Subject: Exelon Nuclear Texas Holdings, LLC
Victoria County Station Early Site Permit Application
Response to Request for Additional Information Letter No. 09
NRC Docket No. 52-042

Attached are responses to NRC staff questions included in Request for Additional Information (RAI) Letter No. 09, dated May 6, 2011, related to Early Site Permit Application (ESPA), Part 2, Sections 02.05.01 and 02.05.03. NRC RAI Letter No. 09 contained twenty-three (23) Questions. This submittal comprises a partial response to RAI Letter No. 09, and includes responses to the following eight (8) Questions:

Figure 1. VCS Site Area Map Illustrating Possible Geomap Fault Surface Projection Uncertainty.

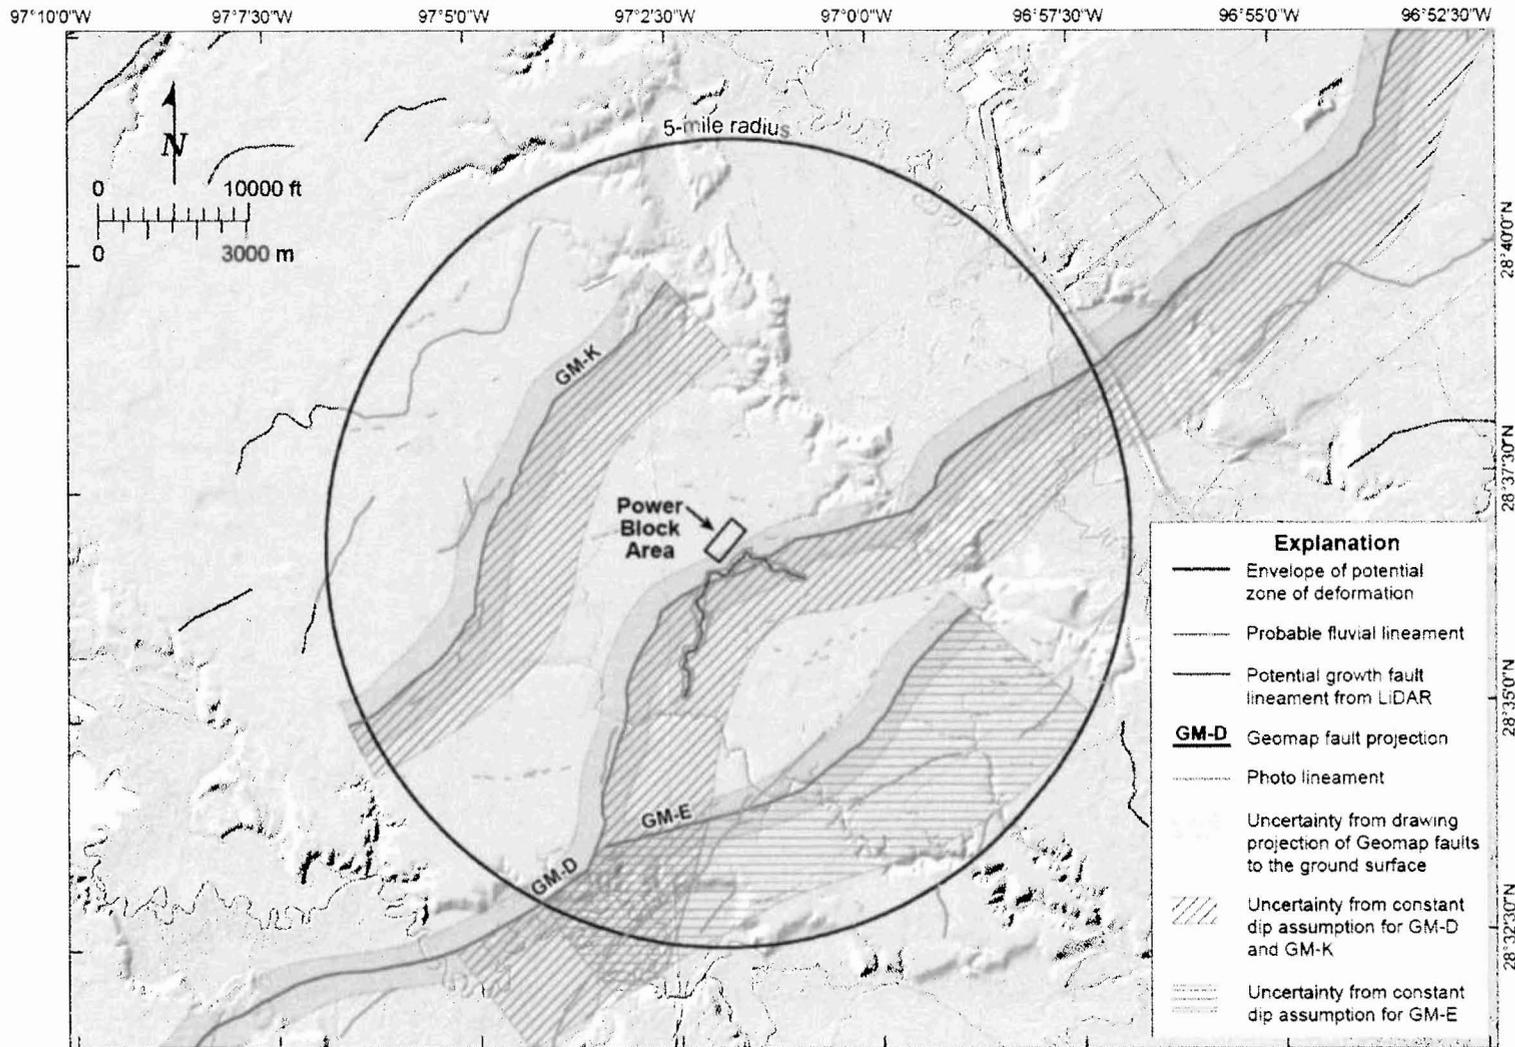
1. Please discuss fault location and fault correlation uncertainties with respect to all specific data sets and as an integrated whole.
2. Please provide a figure(s) to reflect the uncertainties (for example, adjusting the line widths).
3. Please discuss how these uncertainties impact your conclusion that no fault projects beneath the power block footprint.

It is difficult to evaluate any potential uncertainty in the fault locations at depth within the Geomap data due to the vast amounts of data (both proprietary and publicly available) that were used by the Geomap developers in compiling the maps. However, given the relatively dense well spacing within the site area, in particular surrounding growth faults GM-D and GM-E, it is likely that the growth faults are relatively well located. Therefore, for this analysis the locations of the faults at depth are assumed to be accurate, but it is important to note that the Geomap data were not used to as the primary basis for making conclusions regarding the potential for growth faults to cause surface deformation within the power block area (as discussed above). To estimate any potential uncertainty from drawing a smooth projection, an envelope was drawn surrounding the maximum extent of the projected points (Figure 1).

It should be noted that uncertainties in the Geomap data indicate that growth fault D may project within the power block area (Figure 1). However, as discussed above the Geomap data are considerably less accurate than the seismic reflection data (for the ability to project faults to the surface) and the LiDAR data (for the ability to identify surface deformation potentially associated with growth faults), which constrain the zone of potential surface deformation associated with growth Fault D to outside of the power block area. Thus, the uncertainties associated with surface projection of the Geomap data do not impact the conclusion that no faults project within the power block area.

Figure 1 . Geologic Map within the 5-mile Radius.

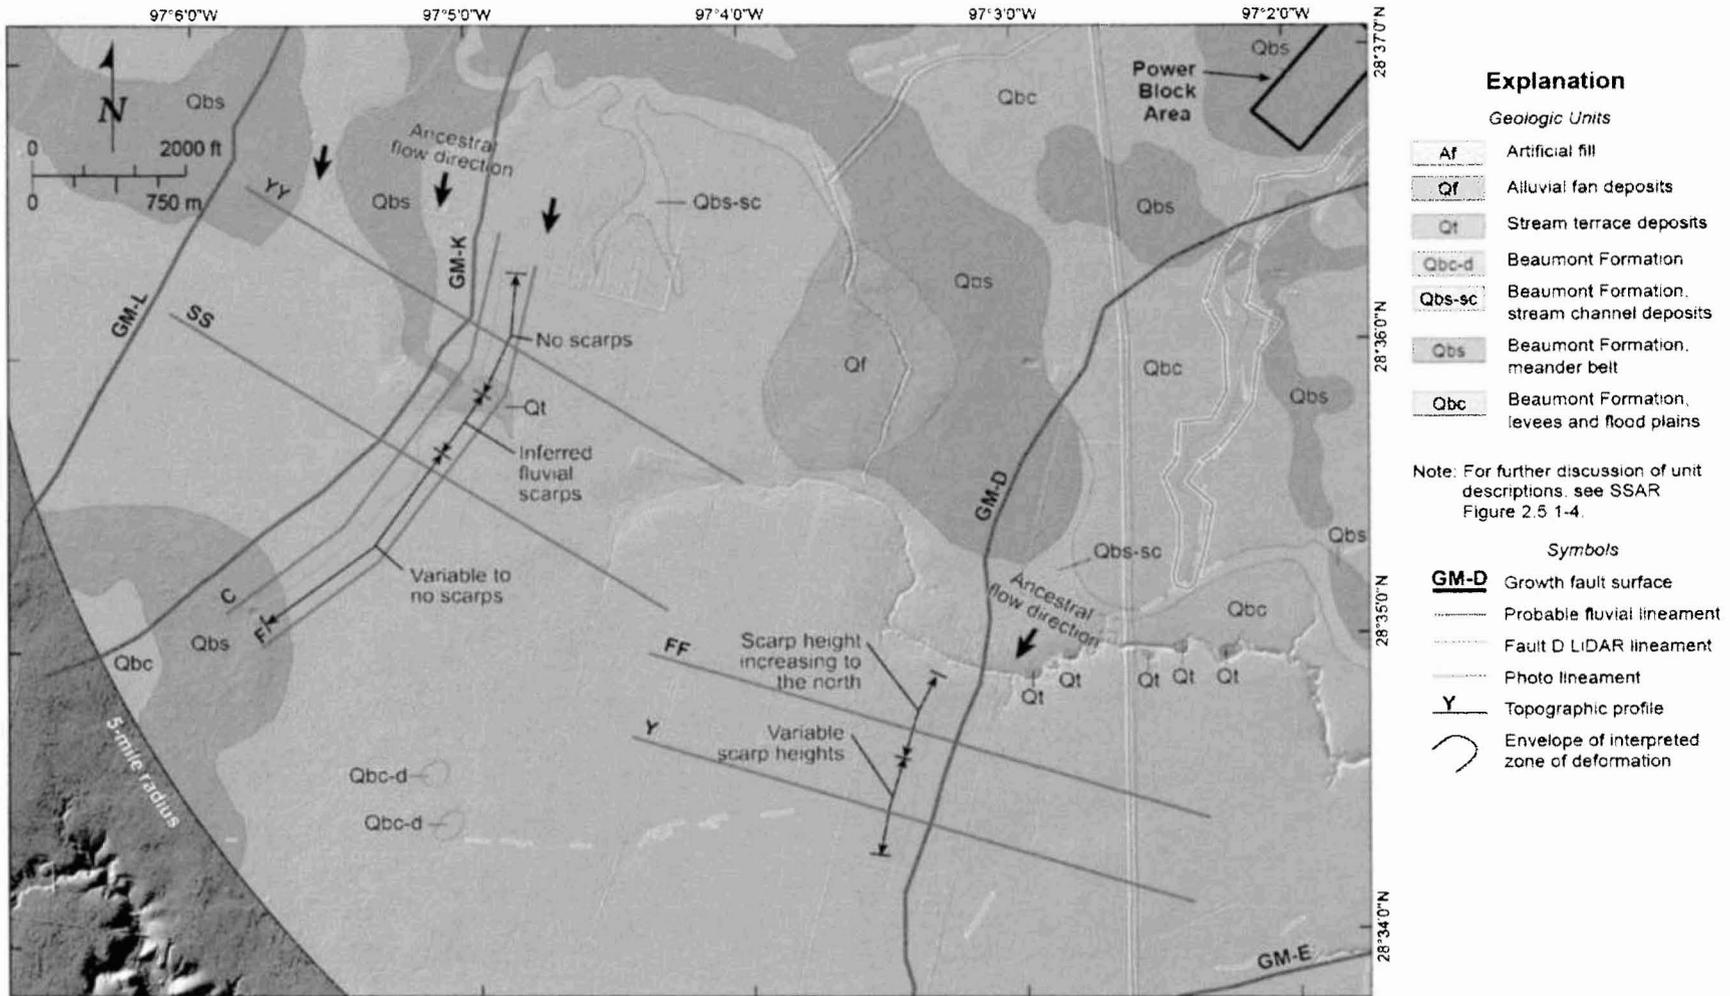
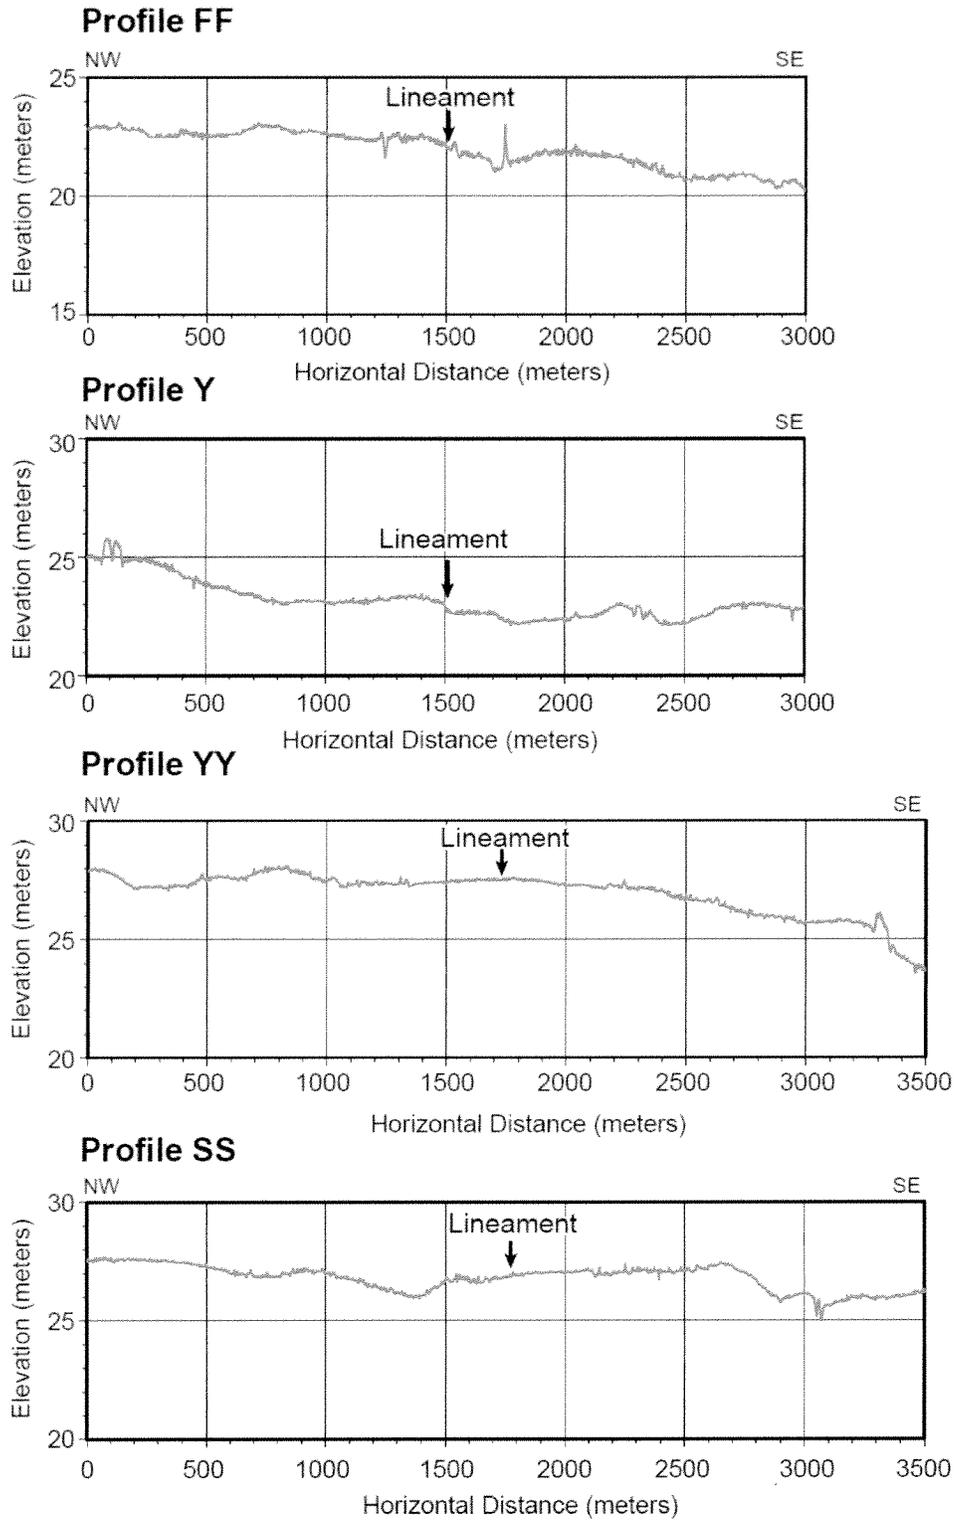
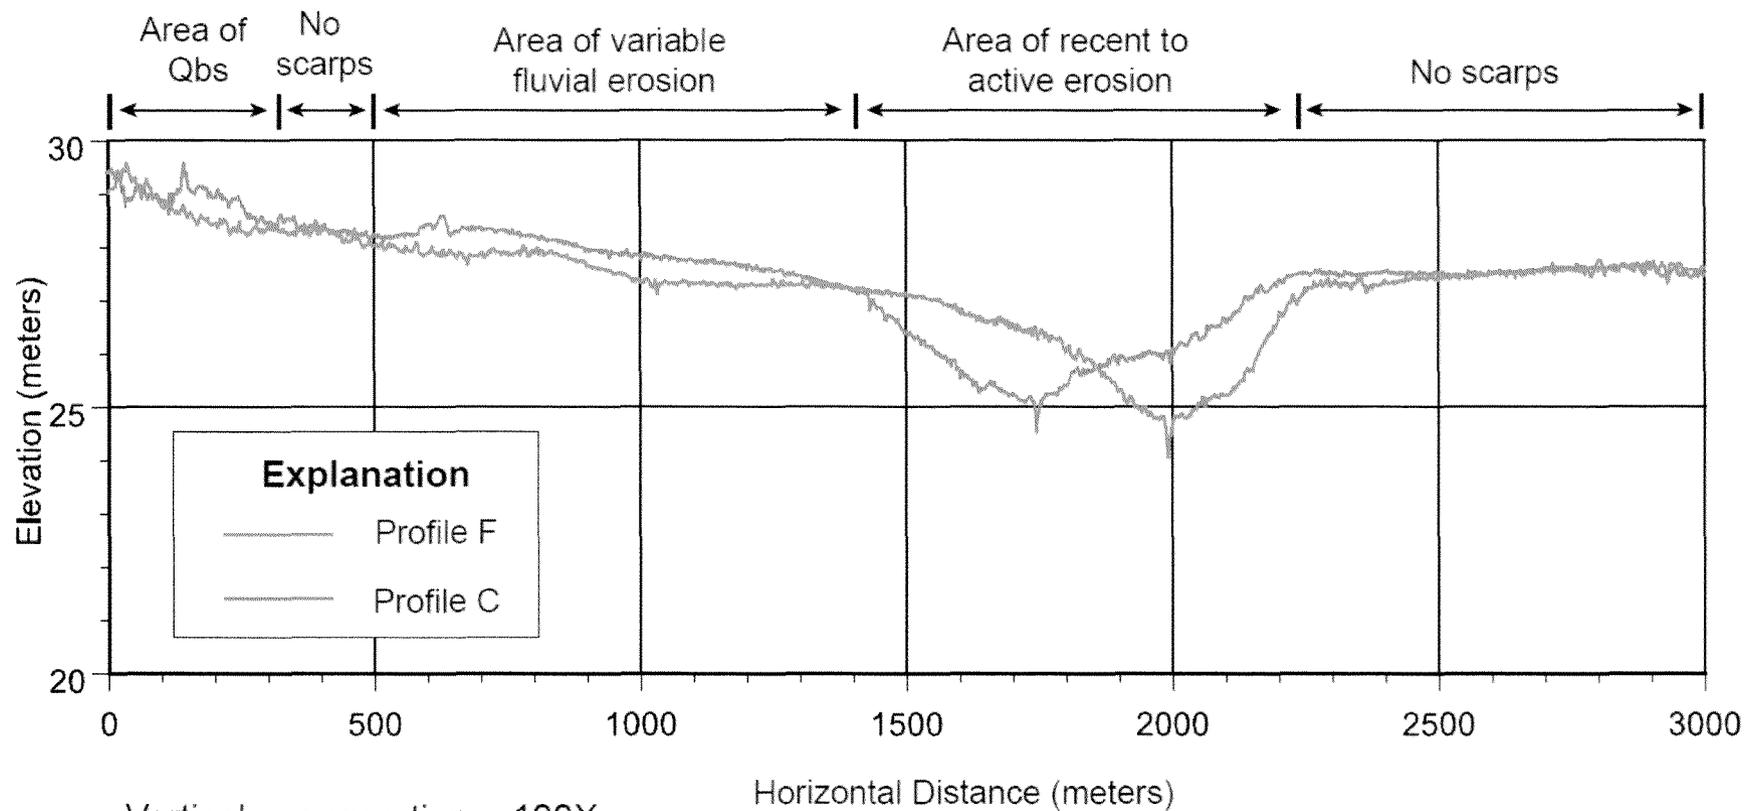
SSAR Section 2.5.1.2.4.2.2 describes criteria used to classify lineaments from airphoto and LiDAR data as related either to growth faulting or to non-tectonic processes. Many lineaments interpreted by you to be of fluvial origin (Figs. 2.5.1-37, 41, 42) lie near and on-trend with surface projections of faults K and D (**see attached Figure 1**). One lineament parallels fault K turn-for-turn for more than 3 km, yet is interpreted as fluvial in origin. Many lineaments interpreted as fluvial scarps trend nearly perpendicular to the regional slope and flow direction, and appear to be southeast-facing, consistent with the slip direction of growth faulting in the region. In support of 10 CFR 100.23 please discuss the alternative interpretation that many of these lineaments are surface manifestations of active growth faulting rather than fluvial processes, and the implications for site safety.

It is important to clarify that the lineaments shown on SSAR Figure 2.5.1-42 and in the NRC Figure 1 were not necessarily 'interpreted as fluvial scarps' but rather "Probable fluvial lineament(s)" and include features identified on aerial photography. For example, these lineaments coincide in places with inferred topographic features identified on LiDAR but do not consistently have surface expression or lateral continuity that can be attributed to the possible surface expression of growth fault deformation. In addition, although these lineaments locally have a different trend than the regional slope and flow direction, the orientation of the features are consistent with the ancestral flow patterns inferred from subtle paleochannels developed on geologic unit Qbs (Figure 1).

These lineaments that locally coincide with mapped inset fluvial terraces that do not support the interpretation that these lineaments are related to growth faulting (Figure 1). For example, the back edge of geologic unit Qt is coincident with the middle of, and parallel to, the lineament adjacent to the surface projection of growth fault GM-K (see Figure 1). If active growth faulting is occurring across this lineament, it is expected that terrace development and stream incision to have occurred in the inferred area of uplift west of the lineament, not downstream of the lineament in the inferred area of subsidence. Similarly, stream incision and terraces are observed downstream of the lineament that is partially coincident with the surface projection of growth fault GM-D (Figure 1). This observed pattern is the opposite of that expected across the general up-on-the-west displacements of growth faults in the VCS site vicinity. More importantly, the associated fluvial scarps are coincident with other inferred fluvial features identified along the lineaments.

The surface expression of the lineaments in question are not consistent with growth faulting but rather exhibit variable topography derived from surface fluvial processes common within this unit. As discussed in SSAR Subsection 2.5.1.2.4, the Beaumont Formation subunit Qbc consists of levee and flood plain deposits that form locally raised topography that appears as lineaments on LiDAR data and aerial photography. For example, comparison of topographic profiles parallel to, and bracketing, the lineament adjacent to the surface projection of growth fault GM-K illustrates that there is either no change in elevation between the profiles (i.e. no scarp) or that changes in topographic relief are consistent with areas of localized erosion and deposition (Figures 1 and 3). In addition, topographic profiles perpendicular to the lineament coincident with the surface projection of fault GM-K document local absence of topographic relief (scarps) across the lineament (Figure 2). Profiles FF and Y across the lineament coincident with the surface projection of fault GM-D show variable localized changes in topographic relief that are not consistent with large-scale, down-dropping of terrain across a growth fault. In particular, profile FF shows topographic relief consistent with a subdued stream channel. Multiple profiles across the lineament show varying scarps heights generally

increasing towards the existing stream channel to the north, consistent with a fluvial origin.

Figure 1a. Stacking Velocities at Intersection of Lines PLJ and GSI.

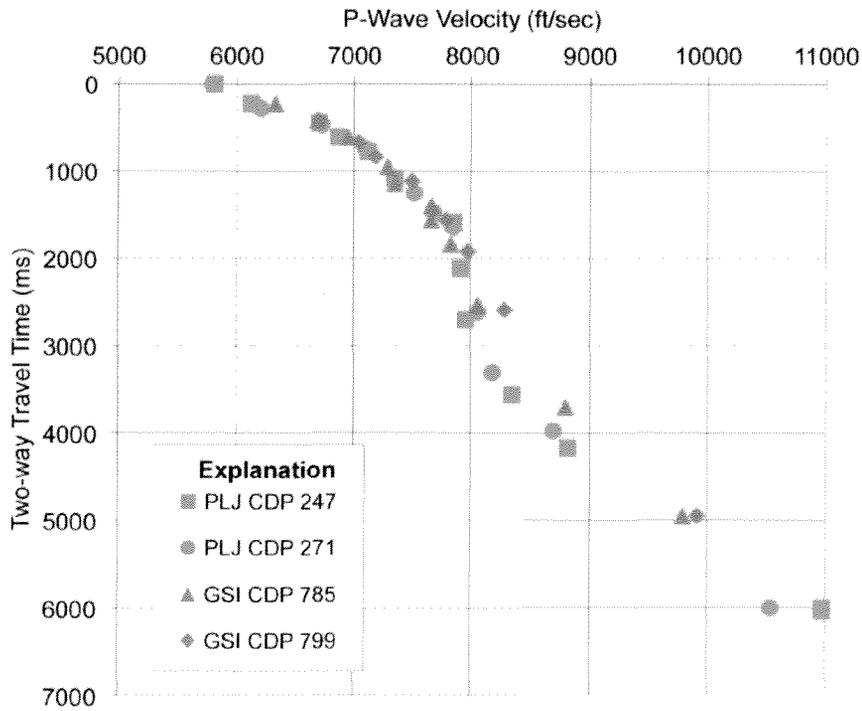
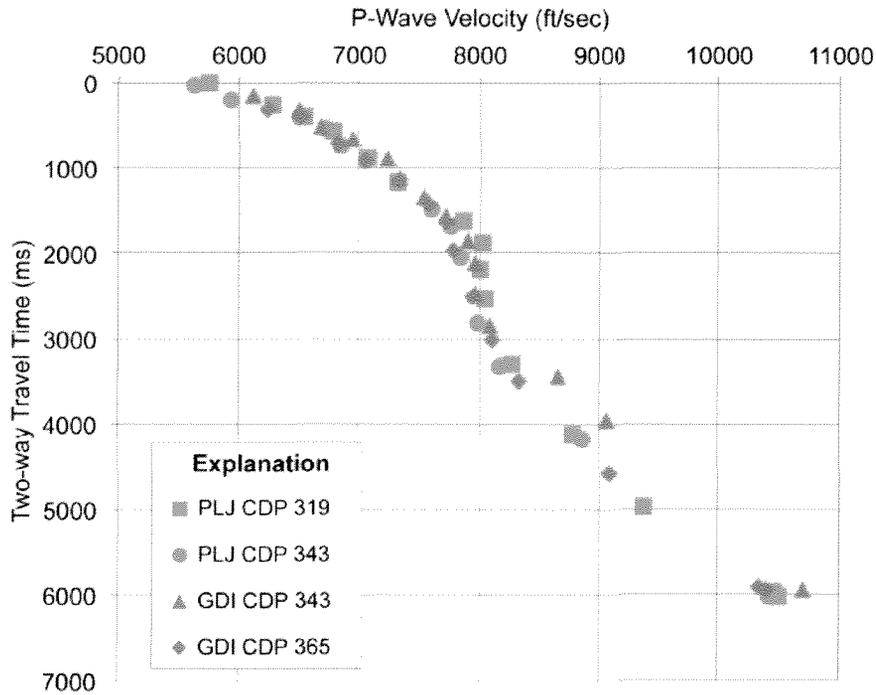
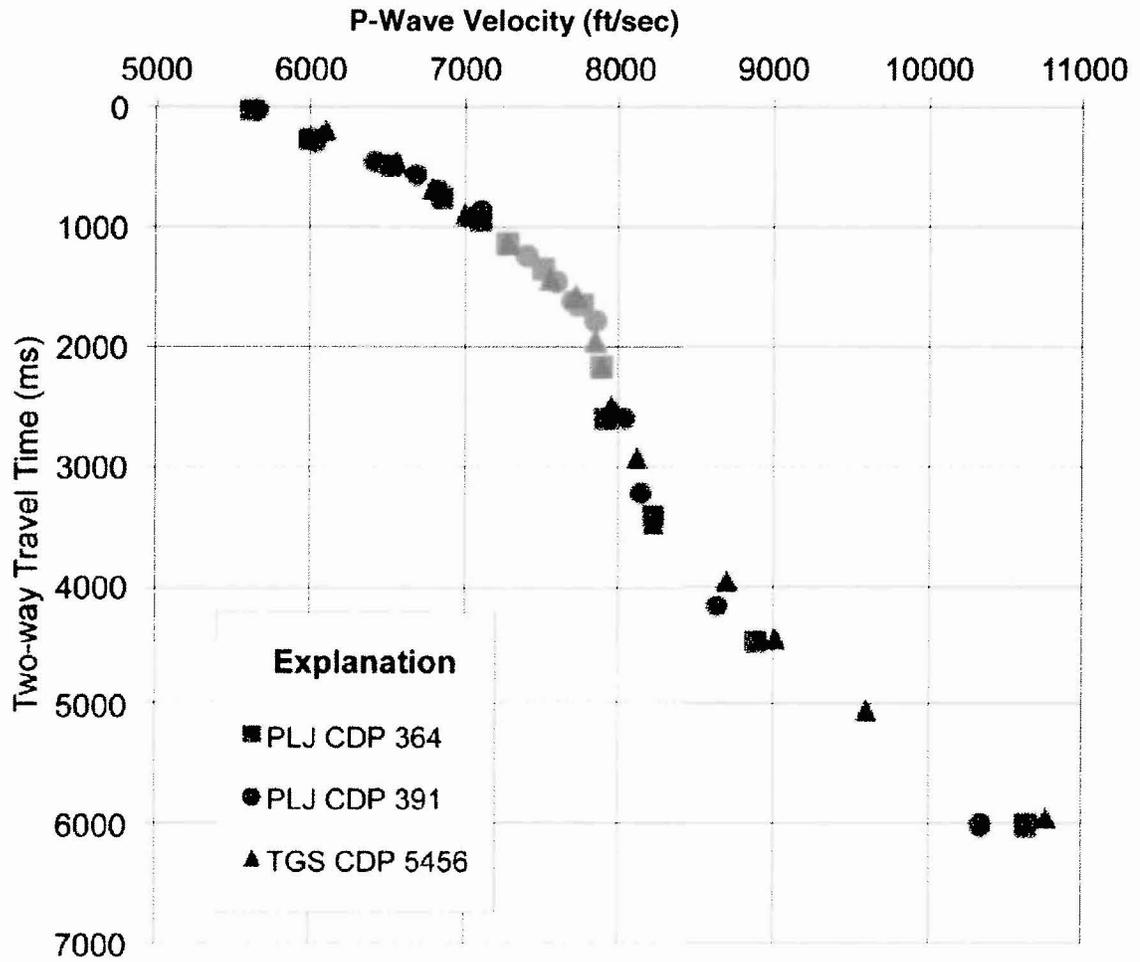
- Provide a discussion on the limitations of this dataset for characterizing growth faults in the VCNPP vicinity
- Describe comparisons of the stacking velocity fields at the profile tie points, and discuss your level of confidence in the interpreted velocity structure
- Describe how sonic log data from deep wells drilled in the vicinity of the VCS site were used in the seismic reflection velocity analysis. For example, were they incorporated directly into the processing or were they compared to the processing-derived velocity field as a quality check?

For each seismic reflection line, the line's interactive stacking-velocity analyses functions are indexed by Common Depth Point (CDP). Selected CDPs were used as the stacking velocity functions for the line. Figures 1a, b, and c show the stacking velocity functions for the CDPs bracketing the intersection of tie-line PLJ with lines GSI, GDI and TGS. The PLJ-GSI intersection occurs between CDPs 247 and 271 for line PLJ and between CDPs 785 and 799 for GSI (Figure 1a). The PLJ-GDI intersection occurs between CDPs 319 and 343 for line PLJ and between 343 and 365 for line GDI (Figure 1b). The PLJ-TGS intersection occurs between CDPs 364 and 391 on line PLJ and at CDP 5456 for line TGS (Figure 1c). The distance between the bounding velocity functions varies between lines, but is between approximately 0.5 km to 1 km. Figure 1 demonstrates that the stacking velocities are consistent at the intersection points (e.g., tie points), especially above 4 seconds where most of the interpreted structure is mapped (see SSAR Figures 2.5.1-45 through 2.5.1-47).
